1990 Corvette: Service Bulletin: SIR Diagnostics and Procedures to Prevent Codes 16 and 26 Due to Corrosion Revised

Subject: SERVICE MAN. UPDATE SEC.9J A/B REV. SIR DIAGNOSTIC PROCEDURE

Model and Year: 1990 CORVETTE

Bulletin Number: 90-436-9J - (11/07/1991)

FORWARD DISCRIMINATING SENSORS Figures 1 & 2 -----

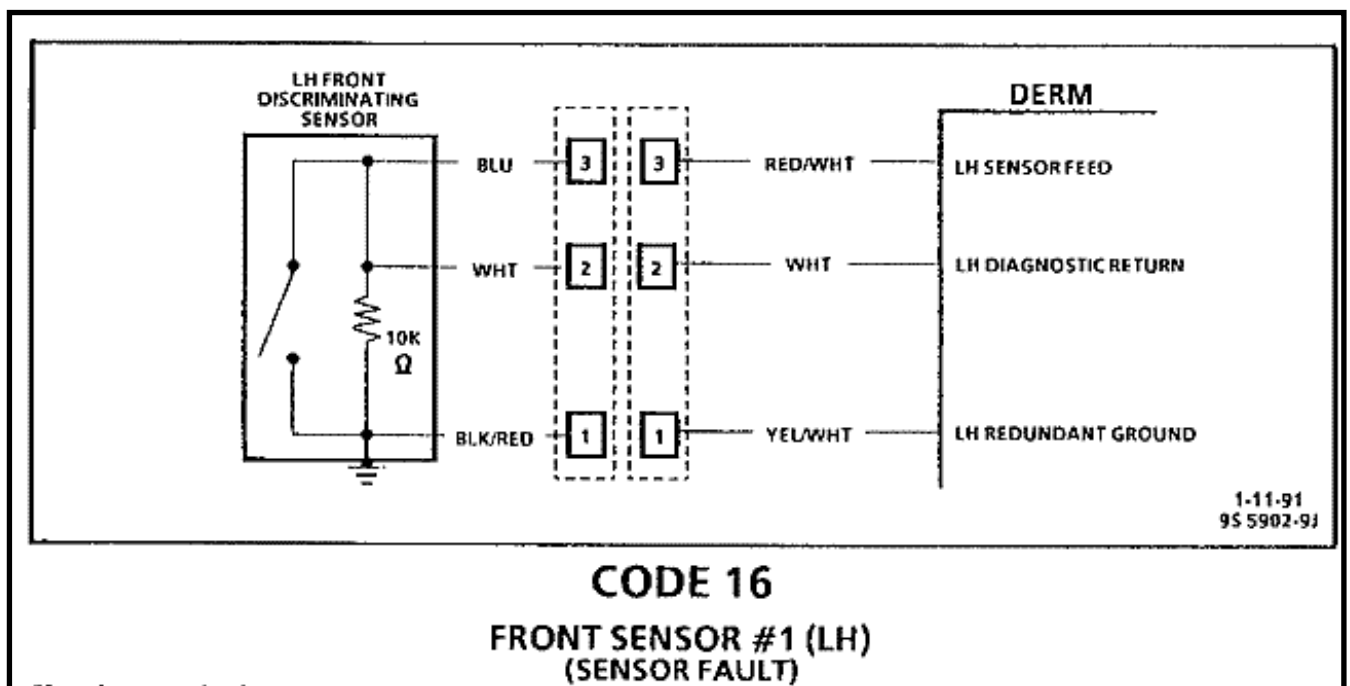
Caution should be used to assure proper location of sensors to the front frame rails. The keying of the sensors to the frame rails through the differently sized mounting bolt holes in the sensor mounting plate should never be modified in the field.

1. Apply a thin layer of special grease P/N 12345579 to the frame rail mounting surface and the mounting flange of the sensor. Do not apply the grease to the mounting bolts or holes.
2. Forward discriminating sensor, with arrow pointing toward front of vehicle.
3. External tooth lock washers, P/N 11501869 (8 mm) and 121753 (6 mm) to mounting bolts.
4. Sensor mounting bolts. Ensure that washers are between bolt head and sensor mounting flange, not between mounting flange and frame rail.

- Front (13 mm head) bolt to 25 N.m (19 lb. ft.) - Rear (10 mm head) bolt to 14 N.m (125 lb. in.)
5. Sensor electrical connection, then clip completed connection into retainer.
 6. ECM and support; refer to DRIVEABILITY AND EMISSIONS (SECTION 6E3).

CODE 16

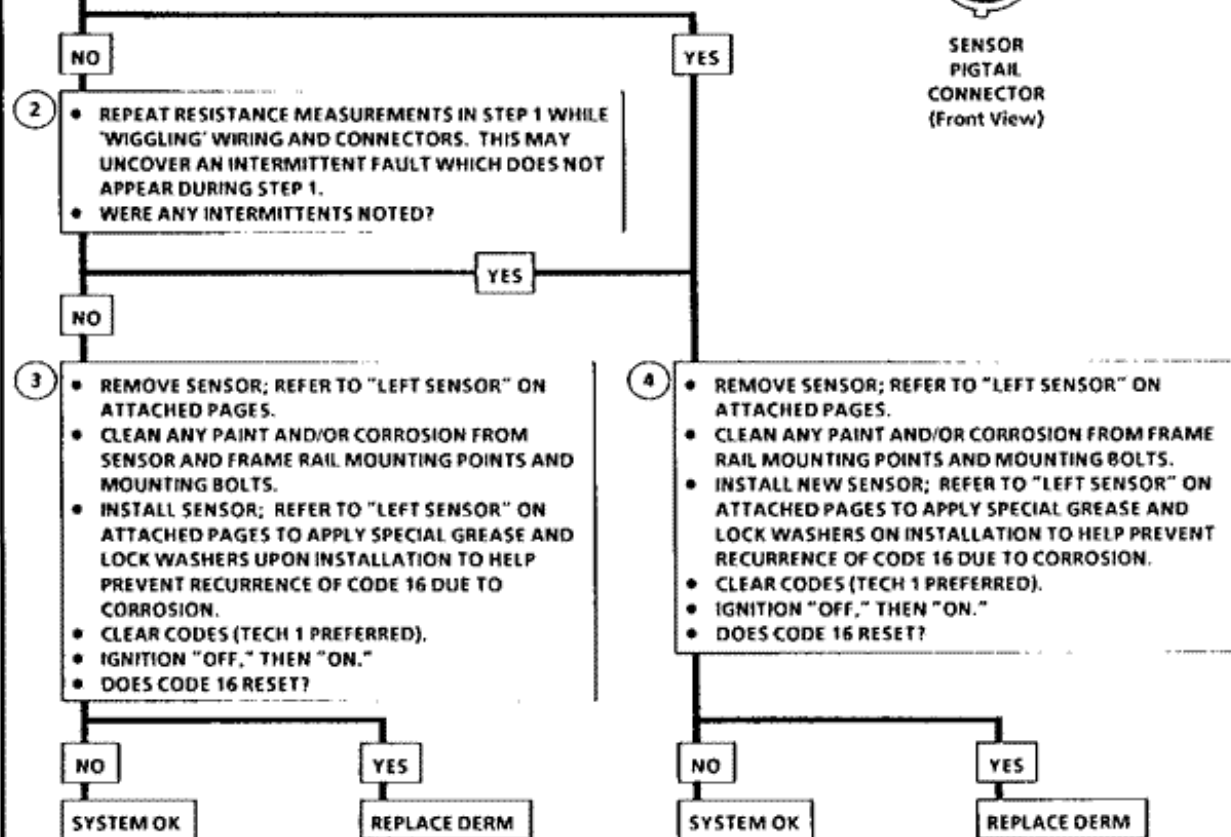
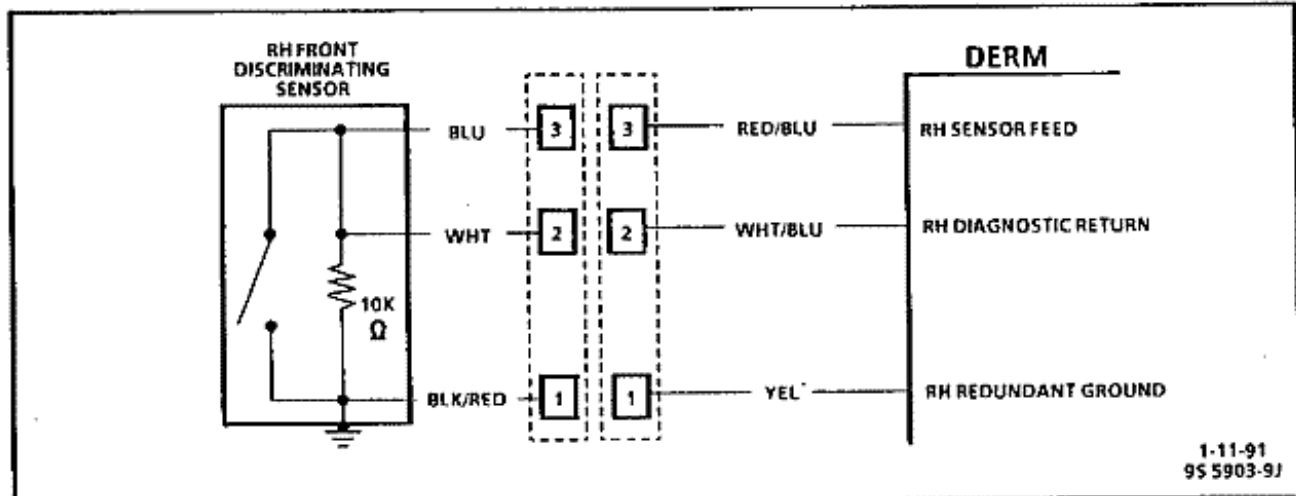
- 1
- IGNITION "OFF."
- DISCONNECT SENSOR CONNECTOR.
- USING ADAPTERS FROM J 37808-10 AND DVM J 34029-A OR DVM J 39200, MEASURE THE RESISTANCE BETWEEN TERMINALS IN THE SENSOR PIGTAIL CONNECTOR AS SHOWN BELOW. NOTE MEASUREMENTS FOR EACH CHECK.

SENSOR TERMINALS	RESISTANCE
1 AND 2	ABOUT 10,000 Ω
1 AND 3	ABOUT 10,000 Ω
2 AND 3	LESS THAN 1 Ω

- WERE ANY OF THE MEASUREMENTS OUT OF RANGE?
